**LAND USE PETITION IN THE BOWIE PLANNING AREA**

Md.-National Capital Park and Planning Commission ID: Bowie Marketplace Residential Conceptual Site Plan, Preliminary Plan #4-16028 and Detailed Site Plan

## MEMORANDUM

**SUBJECT:** Bowie Marketplace Residential (Docket #16-02)

**Figure 27-5.1103.A.3: Building Height Modulation**

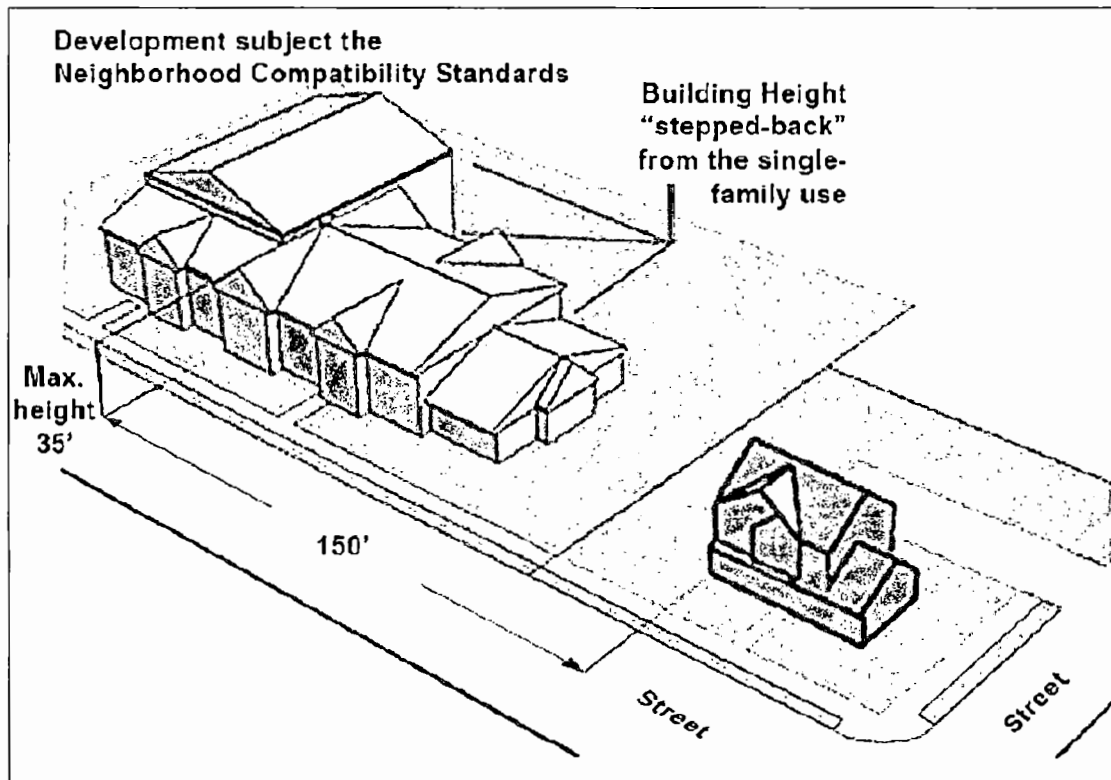
**COMMENT:** With the construction of the proposed 54-foot high apartment building, there is an abrupt transition from the intense retail/commercial uses and buildings on the site and along the MD Route 450 corridor, to the less intense uses of the adjacent residential neighborhoods. The scale, height and mass of the proposed residential building make it incompatible with adjacent detached single family dwellings. The DSP, as proposed, does not demonstrate a gradual transition in the intensity of uses between the C-S-C-zoned property and the R-55-zoned residential properties.

Also, while the proposed standards are not currently applicable to the DSP review because they have not yet been adopted by the Prince George's County Council, the Zoning Ordinance Re-Write project, in Module 2, identifies neighborhood compatibility standards for placement of large-scale buildings near existing single-family detached dwellings (see Attachment #16). The goal of the consulting firm who prepared the draft zoning regulations is to define, through new site planning standards based on best practices observed throughout the country, acceptable thresholds for neighborhood compatibility. The diagram below illustrates what the drafters of the Zoning Ordinance Re-Write consider the minimum standard for building height compatibility when large-scale building development is proposed adjacent to existing single-family homes. The proposed DSP for multi-family apartments at Bowie Marketplace does not meet these minimum design standards.
